HYDRODYNAMICS CONSULTANTS, INC.

Re: WDNR BRRTS #02-41-552537
Westwood Dry Cleaners
8731 W. North Ave
Wauwatosa, WI 53226

Per your review comments dated October 15, 2019 to our 4th Quarterly Groundwater Monitoring Report, we have prepared the following for your review and approval. The responses use the same sequence as your initial comments.

**Change Order #1
ADDITIONAL SITE INVESTIGATION WORKPLAN**

SITE NAME	Westwood Dry Cleaners (#02-41-552537)	FIGURE NO.	1a
FIGURE NAME	Site Utility Line Location Map		
ADDRESS	8731 West North Avenue, Wauwatosa, WI 53226

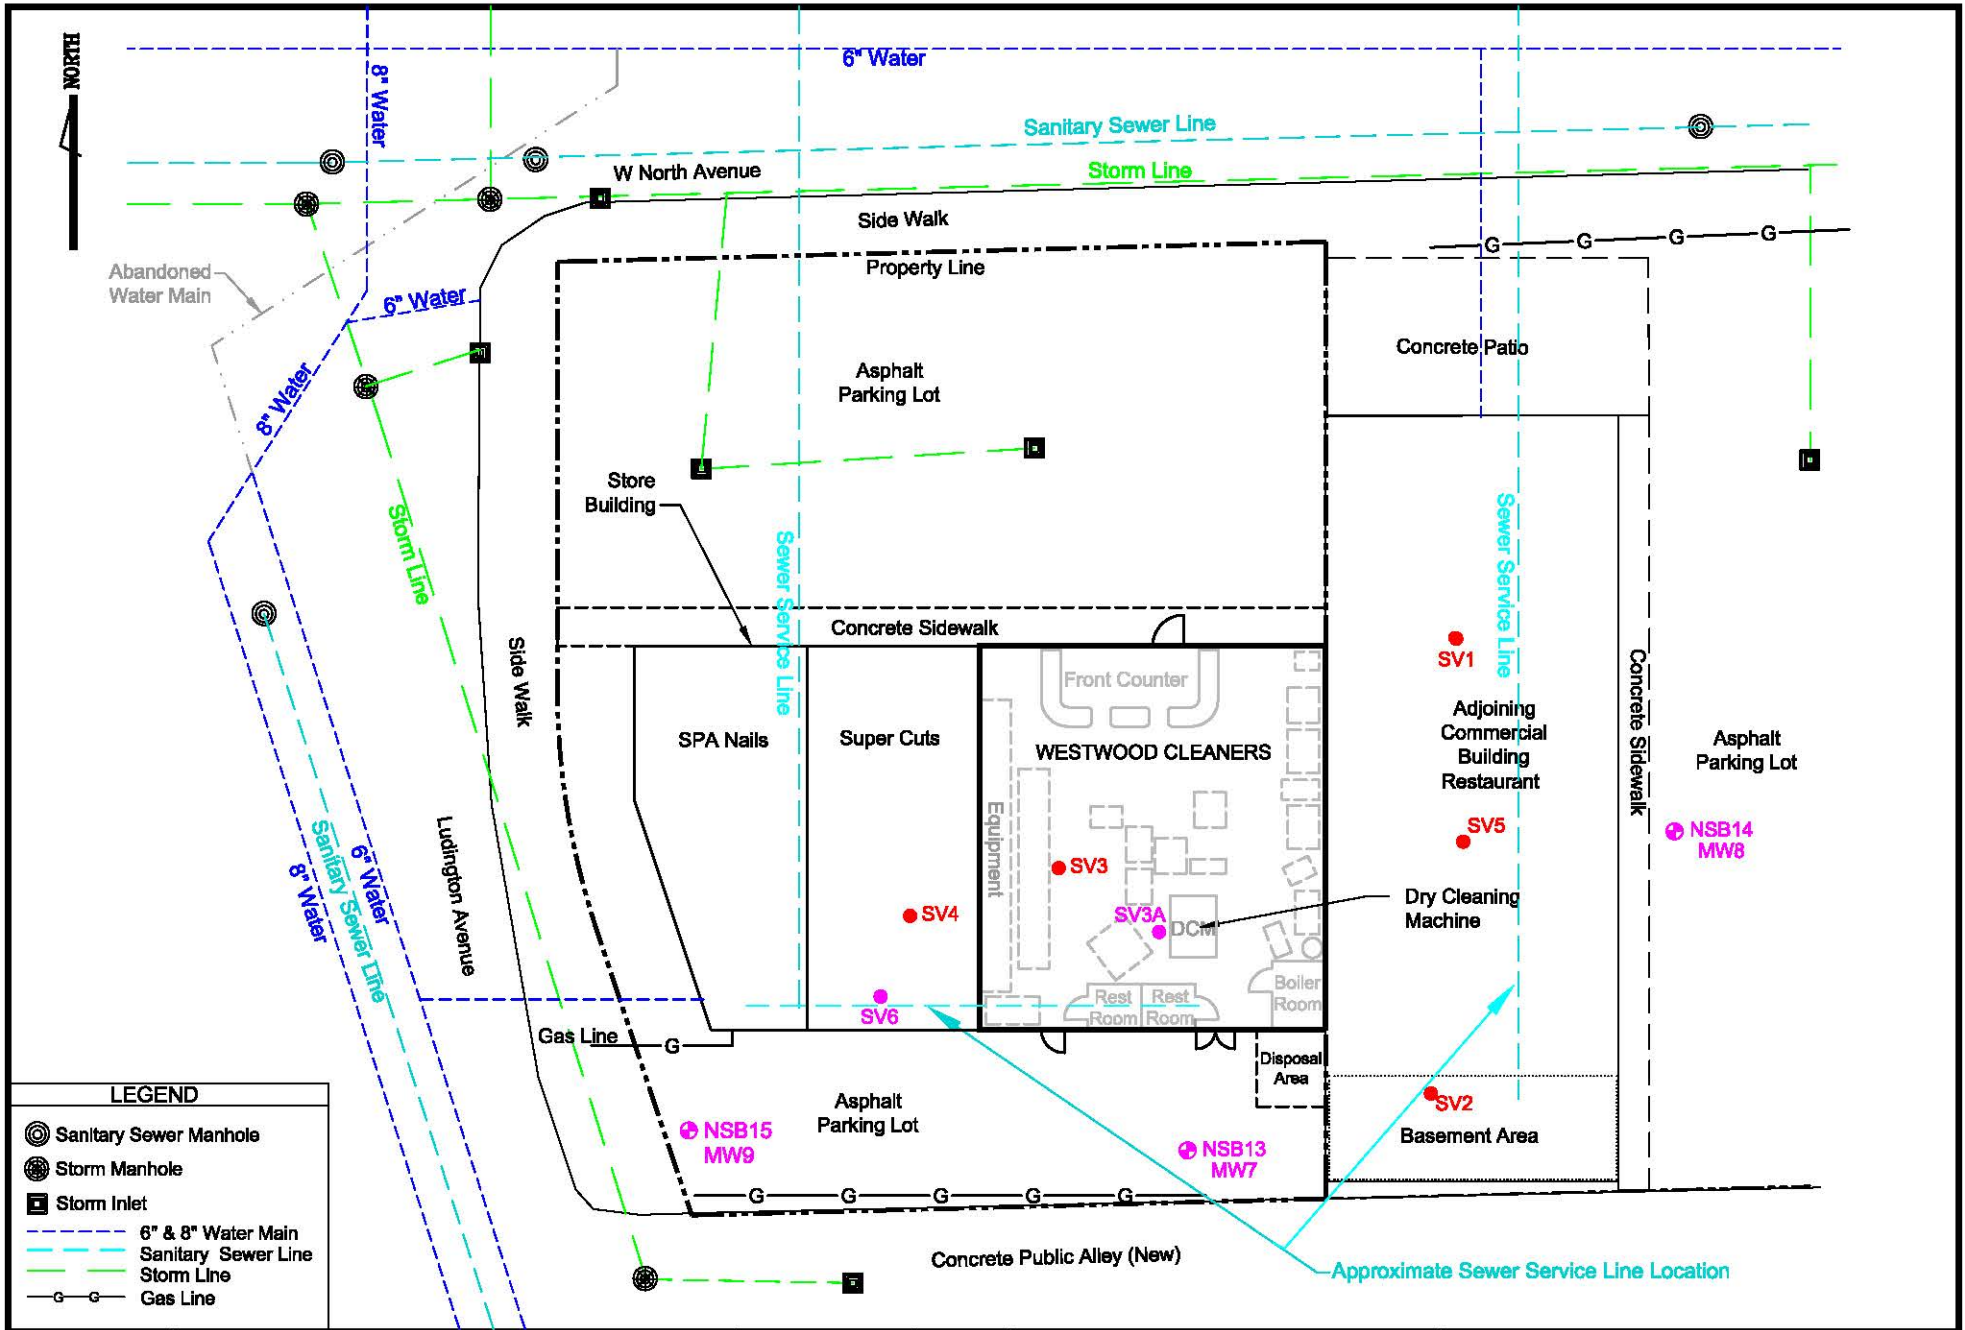
1. (i) *Provide a figure showing the location of the sanitary sewer laterals to the dry cleaner building, SPA Nails, Super Cuts and the Adjoining Restaurant. Discuss the potential for migration of vapors within utilities especially the sanitary sewer and how you will evaluate that as a potential vapor migration pathway. Perform vapor testing of the laterals.*

Response: The City of Wauwatosa, WI provided water and sewer line location information. HDC has put together a Site Utility Line Location Map, Figure 1a for your review. Figure 1a is part of the attached Additional Site Investigation Workplan. At this time, no evidence of vapor migration along any utility line is identified. However, we propose to add a new vapor sampling port (SV6 in Figure 2) near the sewer line in the Super Cuts store.

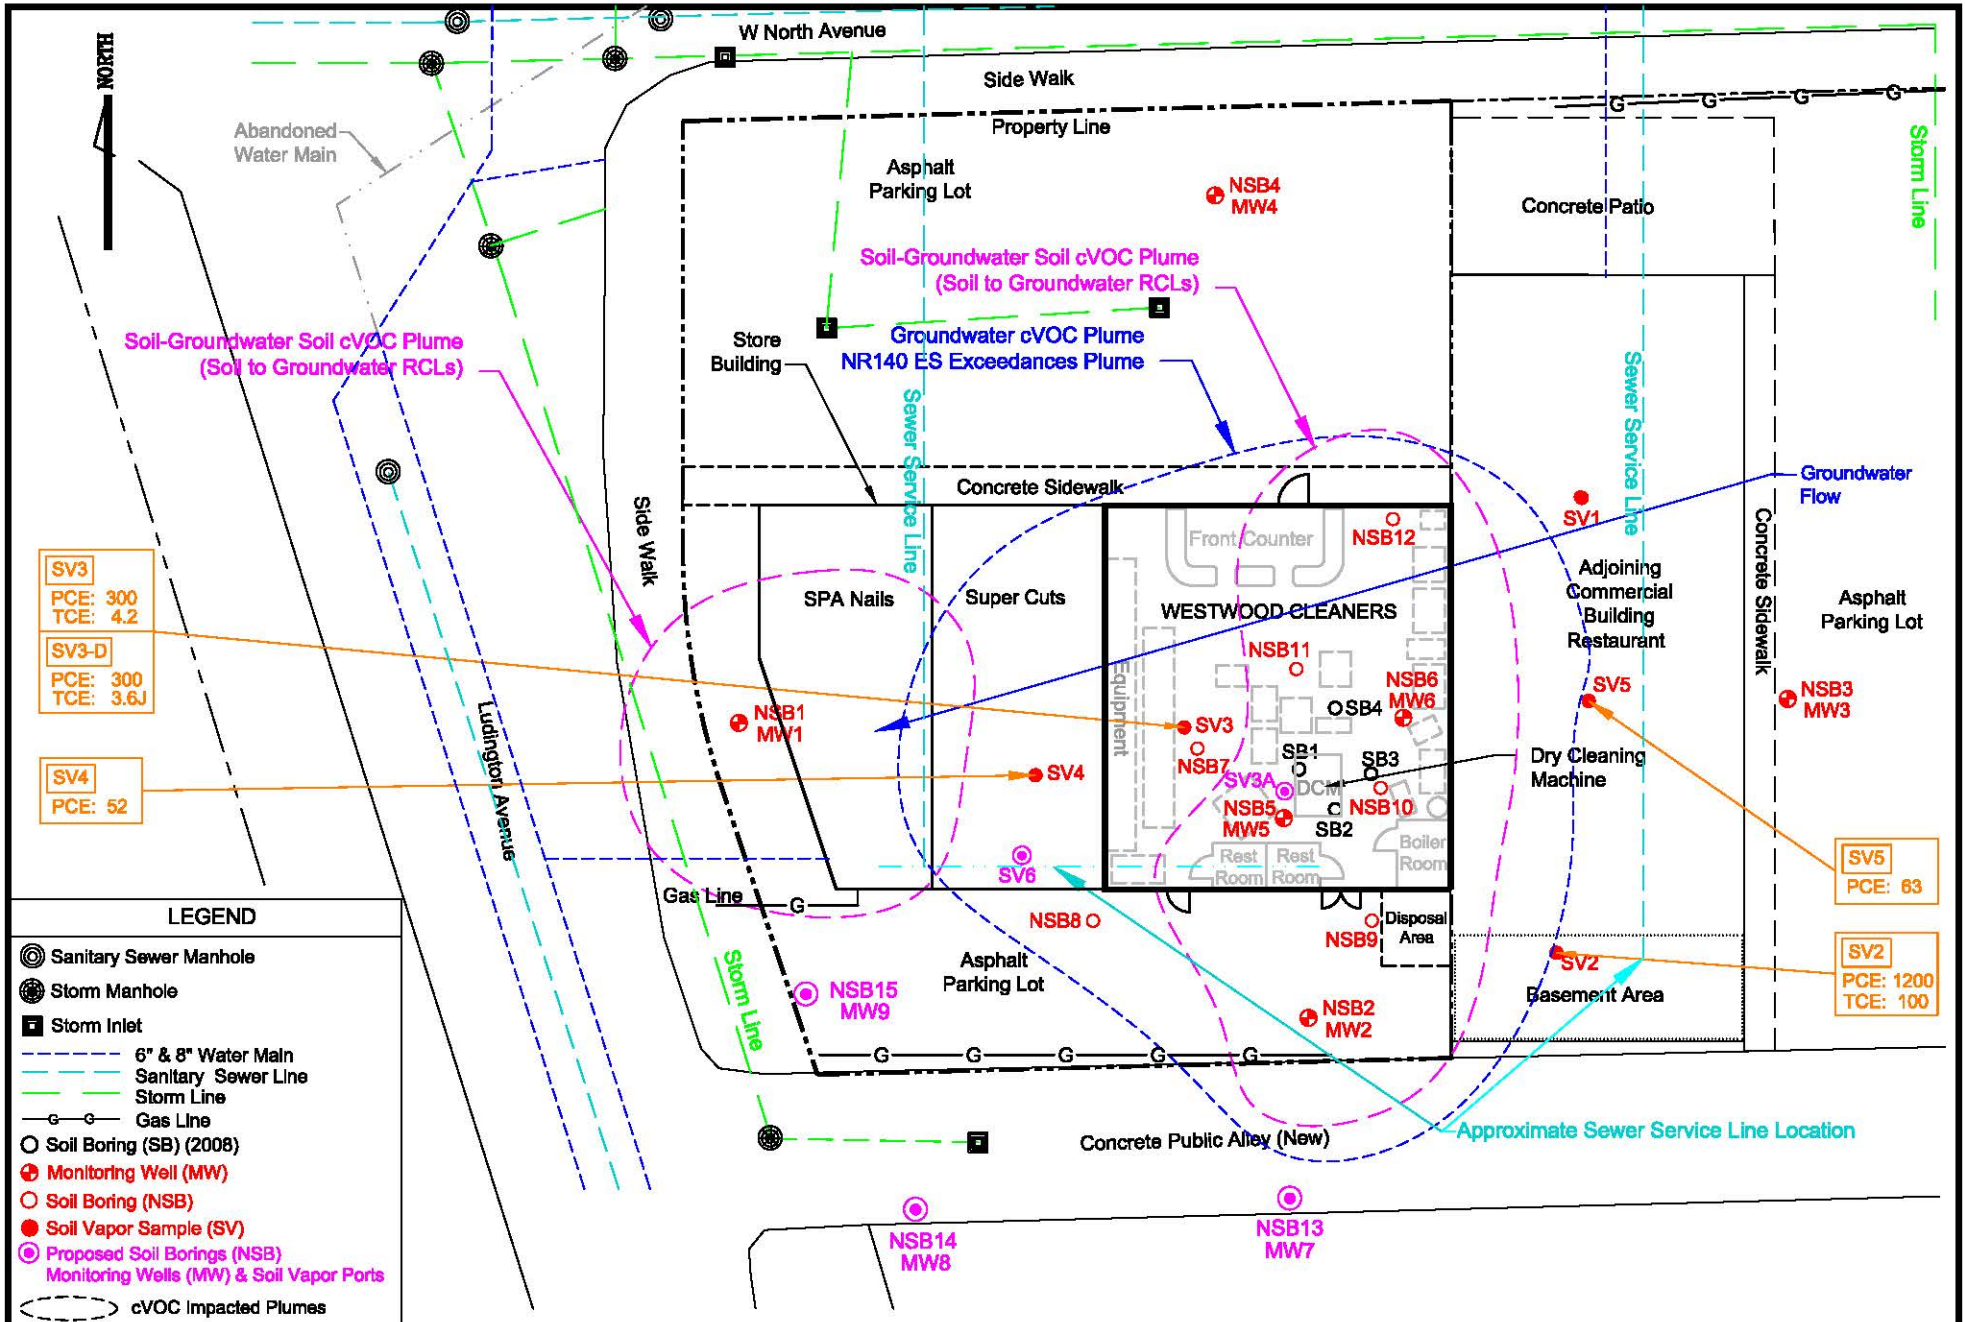
(b) Focus the additional investigation on vapor intrusion versus groundwater. DNR suggests that you install three soil borings that will be sampled and converted to groundwater monitoring wells. Remove all proposed soil borings PSB1, 4, 5, 6, 7 and PSB8 and leave PSB2 and PSB 3 renamed as NSB13, and NSB14 that will be converted to MW-7 and MW-8). Add a new proposed soil boring, PSB15, in the southwest corner of the Asphalt Parking Lot that will be converted to MW-9.

(c) Add a new sub slab vapor point near the dry-cleaning machine location shown on Figure 3, named as SV-3A and another vapor point north of SV-4 in the Super Cuts space and name it SV-6.

Response: We have revised the proposed sampling location map. Please see Figure 2, Additional Soil Boring/Monitoring Well & Soil Vapor Port Location Map, which is part of the attached Additional Site Investigation Workplan.

Response: HDC has revised the proposed sampling location map. Please see Figure 2; Additional Soil Boring/Monitoring Well & Soil Vapor Port Location Map, which is part of the attached Additional Site Investigation Workplan. HDC proposes to move SV6 to the back of the store near the sewer service line area because the business owner is very reluctant to allow us to damage the new floor and disturb customers. Also, this will help to assess the potential soil vapor migration along the sewer line.

SITE NAME	Westwood Dry Cleaners (#02-41-552537)	FIGURE NO.	4a
FIGURE NAME	B-B' Soil & Groundwater cVOC & Geological Cross Section		
ADDRESS	8731 West North Avenue, Wauwatosa, WI 53226

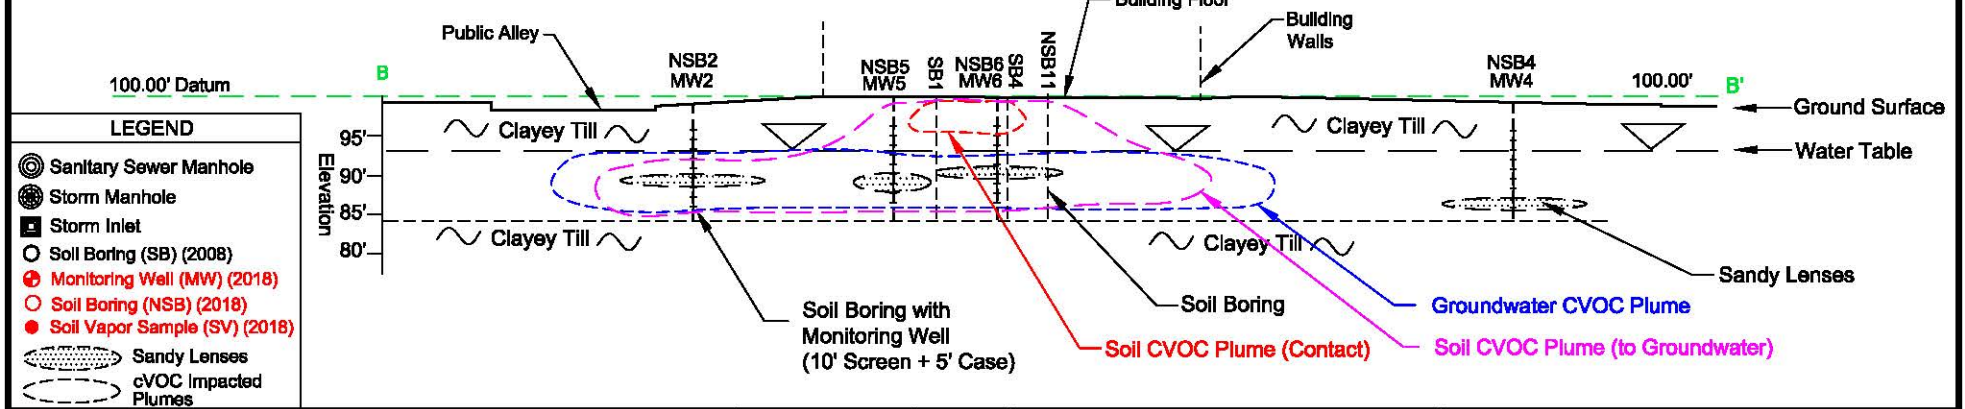
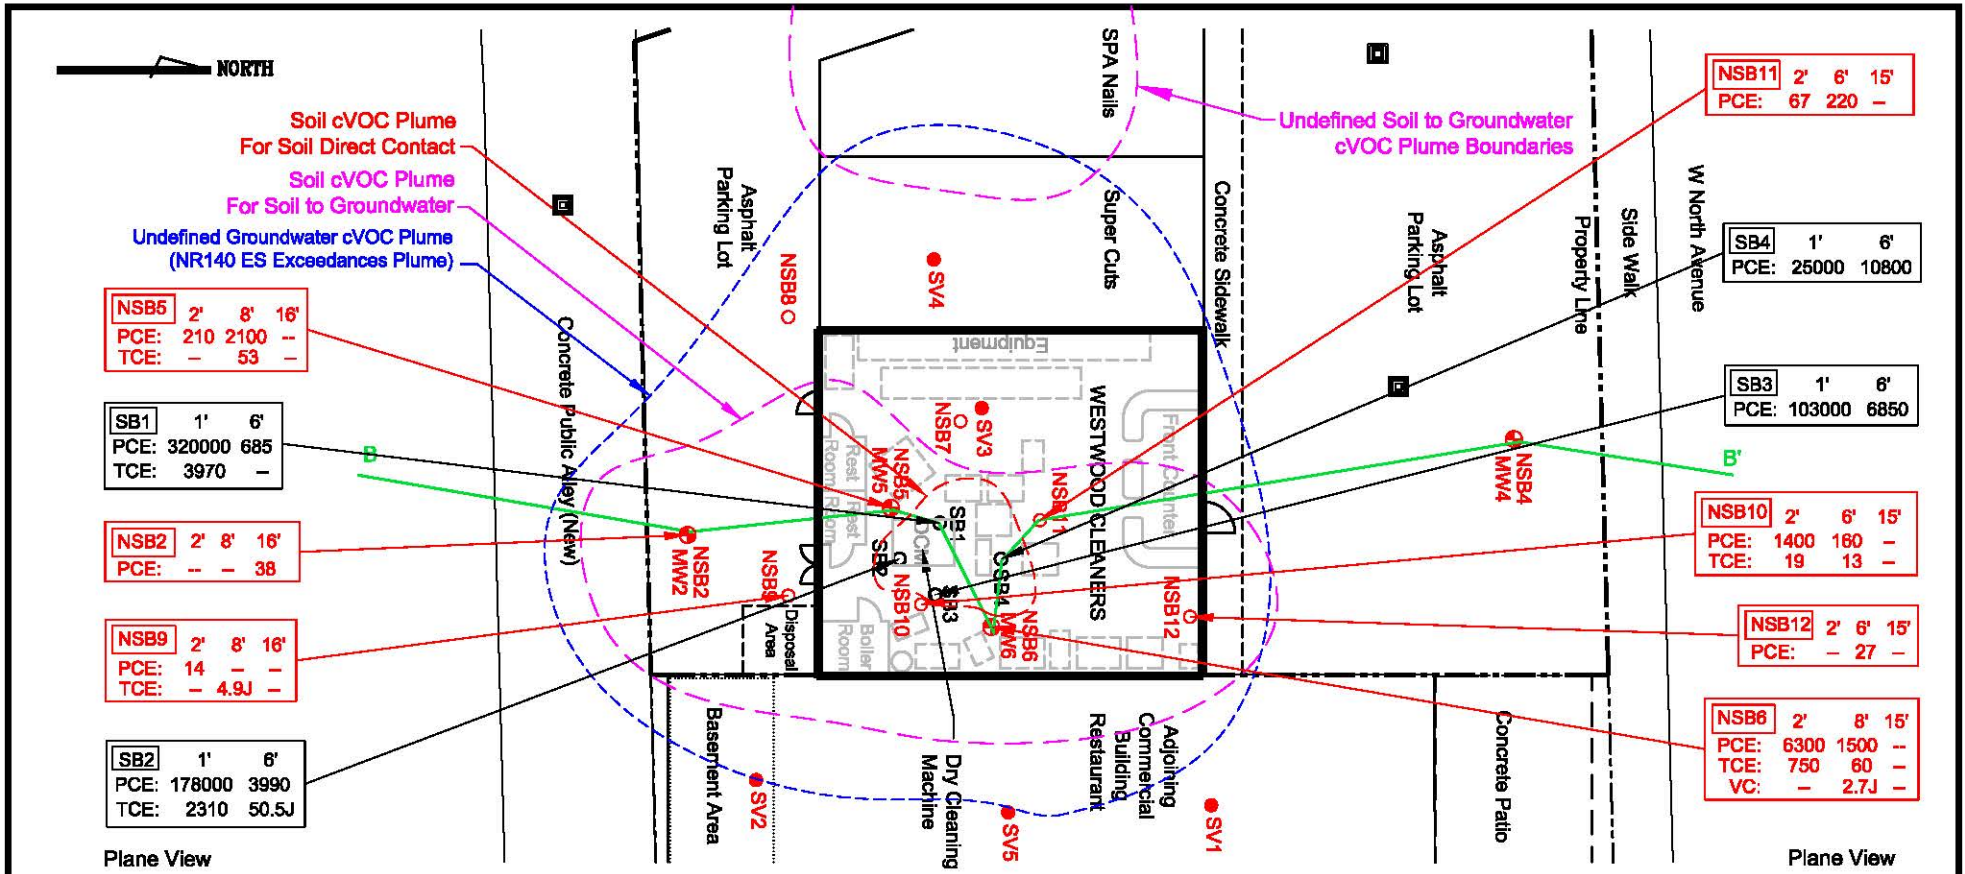
- (ii) *Please add soil contamination data on Cross-Section B-B`.*

- (iv) *NSB (MW1) on the Cross-Section B-B` is mislabeled, it should be labelled NSB2 (MW2).*

Response: Soil contamination data has been added. Please see Figure 4a, B-B' Soil & Groundwater cVOC & Geological Cross Section, which is part of the attached Additional Site Investigation Workplan.

Response: Correct of label has been made. Please see Figure 4a, B-B' Soil & Groundwater cVOC & Geological Cross Section, which is part of the attached Additional Site Investigation Workplan.

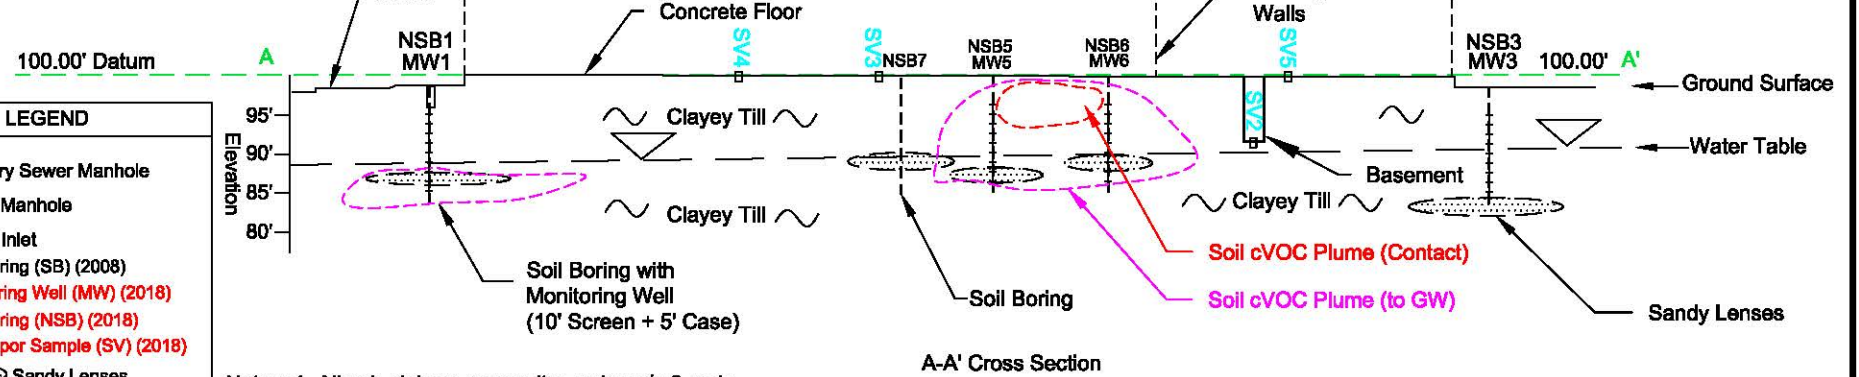
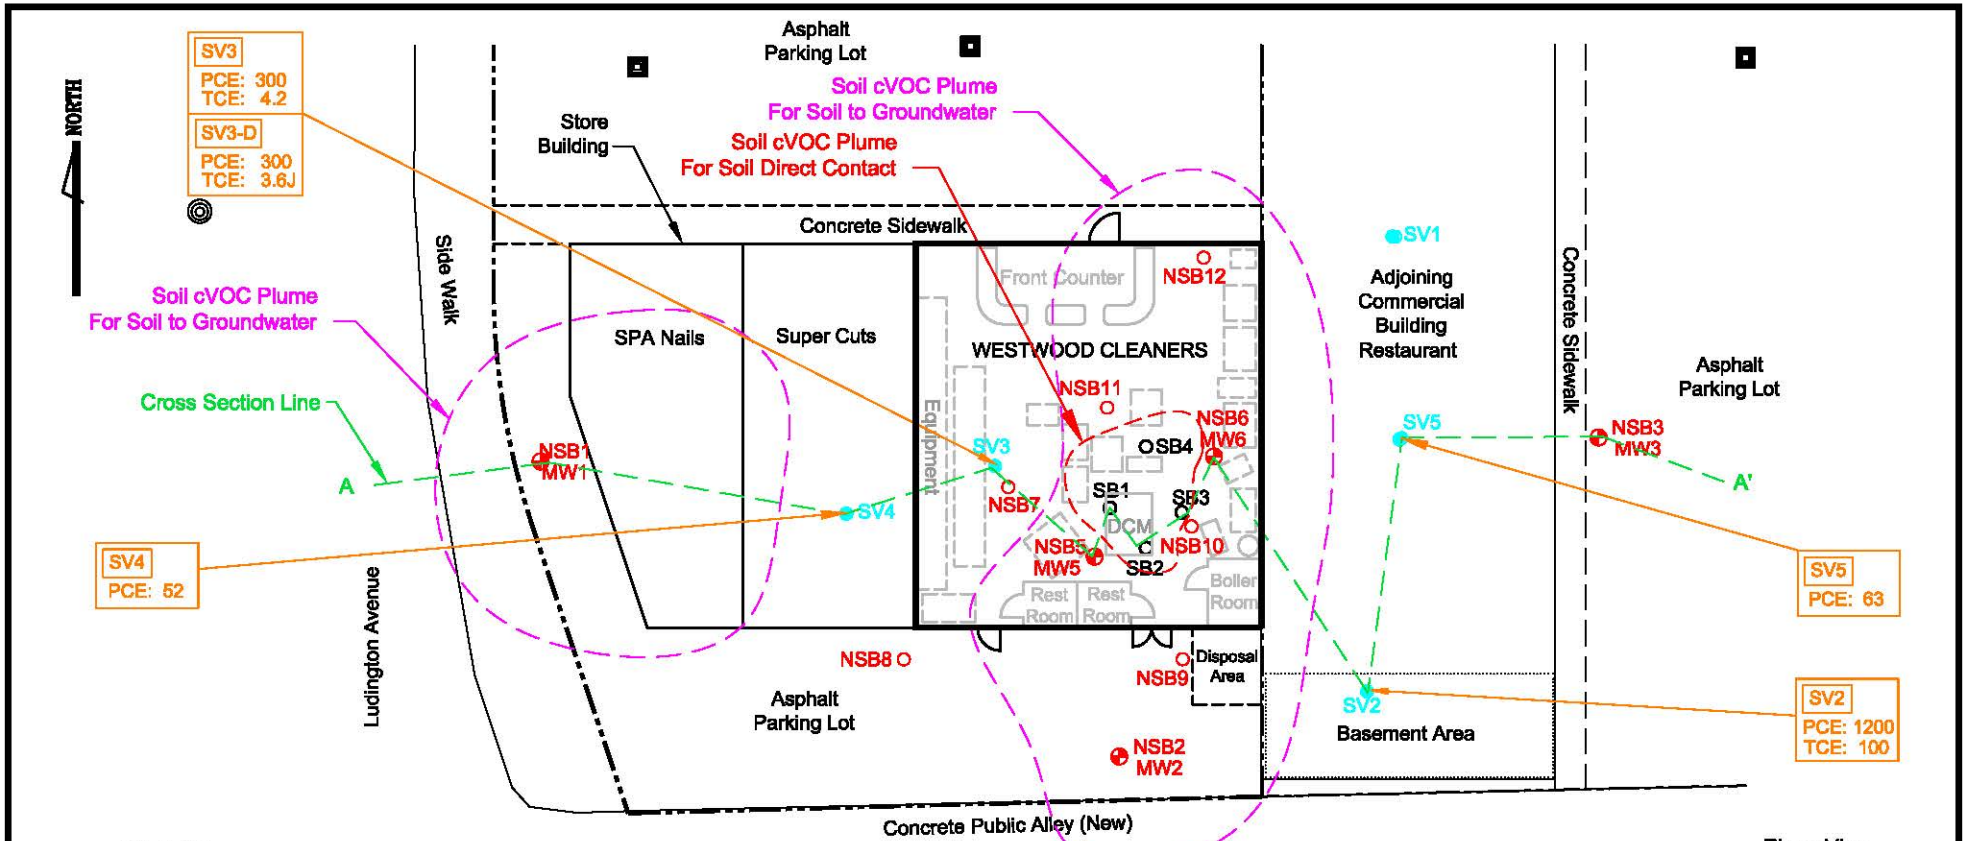
- (iii) *Prepare an E-W cross-section from NS-B3 to NSB1 and include soil vapor points.*

Response: HDC has included an E-W cross section including vapor points for your review. Please see Figure 5a, A-A' Soil & Soil Vapor cVOC & Geological Cross Section, which is part of the attached Additional Site Investigation Workplan.
